**MINNKOTA POWER COOPERATIVE, Inc. and
SQUARE BUTTE ELECTRIC COOPERATIVE**

**FOLLOWUP RESPONSES TO PRESENTATION and
NDDH REQUEST FOR ADDITIONAL INFORMATION
SUPPLEMENTAL NO_x BACT ANALYSIS STUDY
MILTON R. YOUNG STATION UNIT 1 and UNIT 2
REGARDING SCR ECONOMIC FEASIBILITY**

February 11, 2010

MR Young Unit 1 PSH Outlet Temperatures

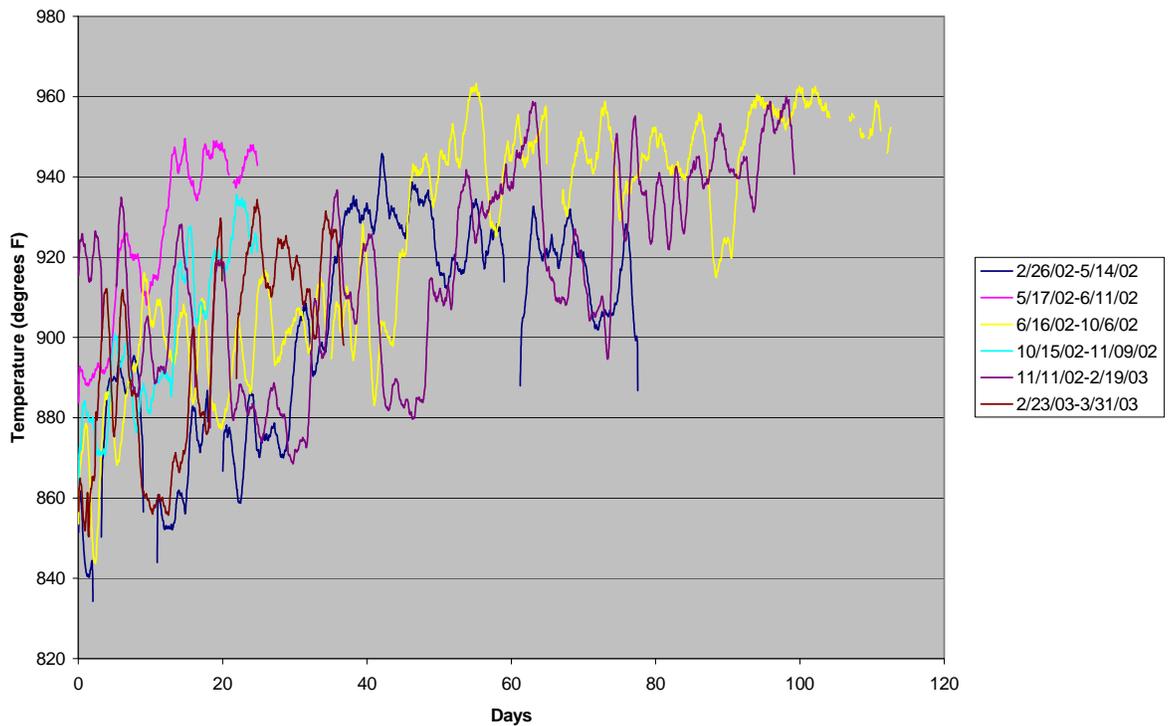
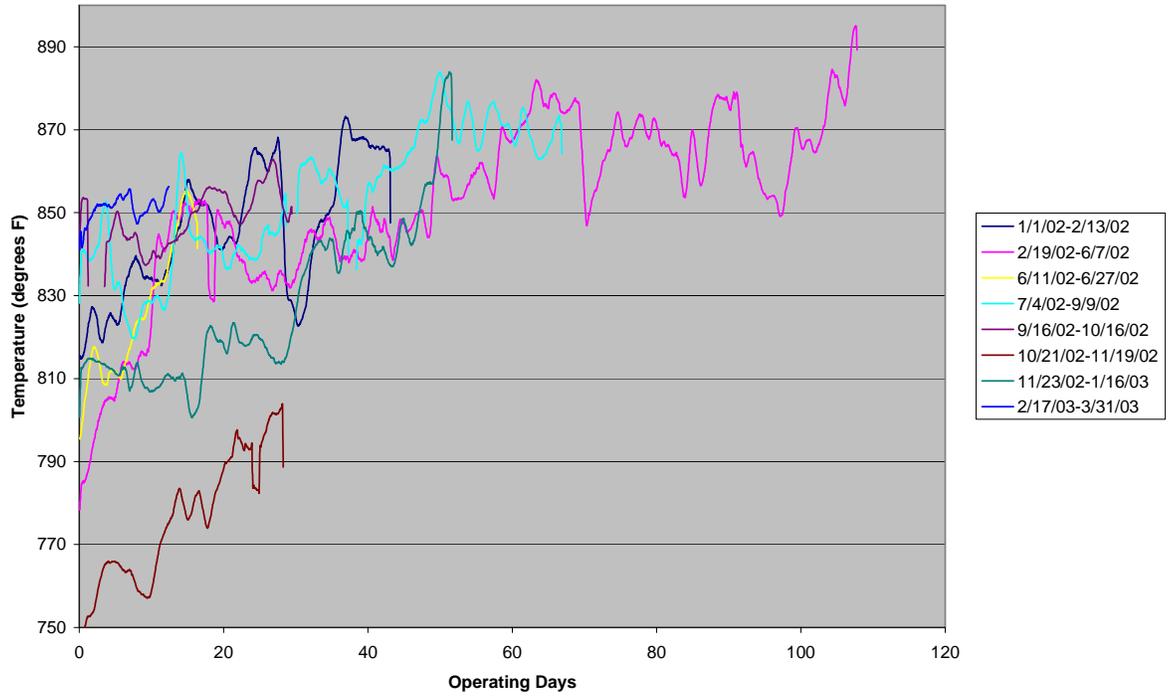
NDDH Request #10: Provide additional clarification and technical justification regarding Minnkota's determination that the units at MRYS are boiler limited and cannot generate additional steam for flue gas reheating purposes.

The steam turbine-generators at MRYS have a given output (gross megawatts) based on steam pressures, temperatures and flow rates related to the boilers. Removing high pressure/high temperature steam to use for flue gas reheating will directly cause a reduction in electrical output. This output reduction cannot be compensated for by increased boiler steam generation without unreasonable consequences. The boilers generate steam based upon their fuel heat input (firing) rates and capacities to absorb the heat created from the fuel combustion. The efficiency of converting fuel heat to steam to megawatts (heat rate or Btu per gross kilowatt) is limited by many factors. Fuel characteristics and boiler capacity are factors that impact heat rate (efficiency) that are not easily changed in the positive direction. The current fuel quality coming from the adjacent mine is not within the original design parameters of the boilers.

Because of the firing type (cyclone) and characteristics of North Dakota lignite burned and resulting flue gas emissions and ash produced at MRYS, the amount of fouling of the heat-absorbing surfaces within the boiler system is severe. These fouling conditions cause high exit flue gas temperatures that eventually reach the maximum limit recommended for maintaining the integrity of the air preheaters. This is indicated by the

time-temperature graphs previously provided¹³ and repeated below. The rate of boiler surface fouling increases significantly as more coal is fired, especially at maximum sustainable firing rates.

Due to the sticky character of the ash deposits, an “arsenal” of sootblower and water lance equipment is employed by Minnkota in an attempt to reduce the rate of fouling accumulations during boiler operations and remove these deposits during frequent boiler outages. These boiler cleaning outages occur every three to four months depending on the specific unit and the fuel quality delivered during the period. If the firing rate is increased to generate more steam for other heating purposes, the frequency of the cleaning outages must be increased. If the accumulated deposits are not removed, the frequency of the cleaning outages must be increased or the firing rates must be reduced and thus reduce the steam and electrical output of the boilers and steam turbine-generators. There is not “excess steam available for flue gas reheating” that would allow Minnkota to avoid reduced annual power generation.

SKETCH SK - FD1

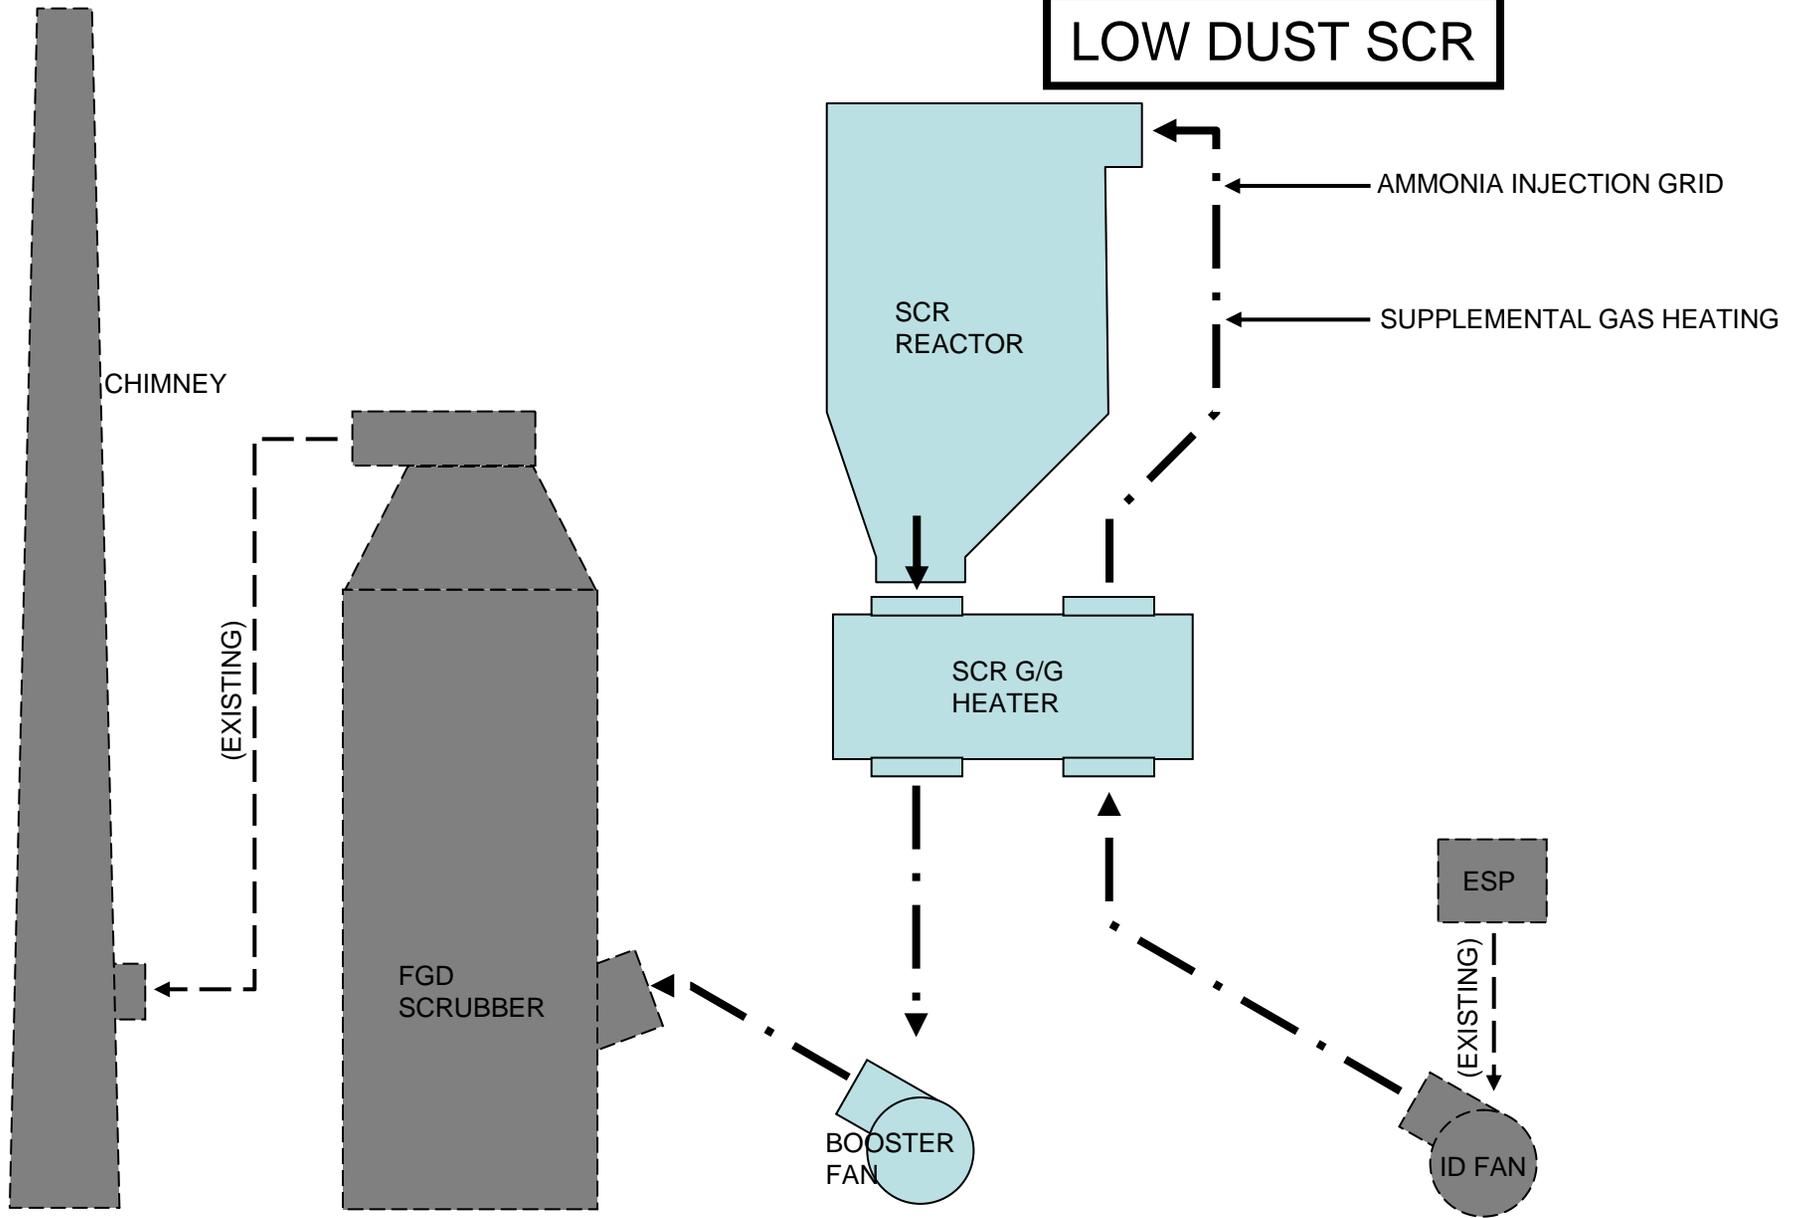
NDDH Request #6: More details, including calculations, must be supplied to justify the pressure drops and parasitic loads associated with the SCR configurations.

For low dust SCR cases, new ductwork would be connected downstream of the existing induced draft fans' outlets and a new booster fan for each reactor would follow the GGH outlet after the SCR reactor, discharging to the existing flue gas desulfurization (FGD) system absorber inlet duct¹¹.

¹¹ See attached sketch for low-dust SCR equipment and ductwork conceptual arrangement.
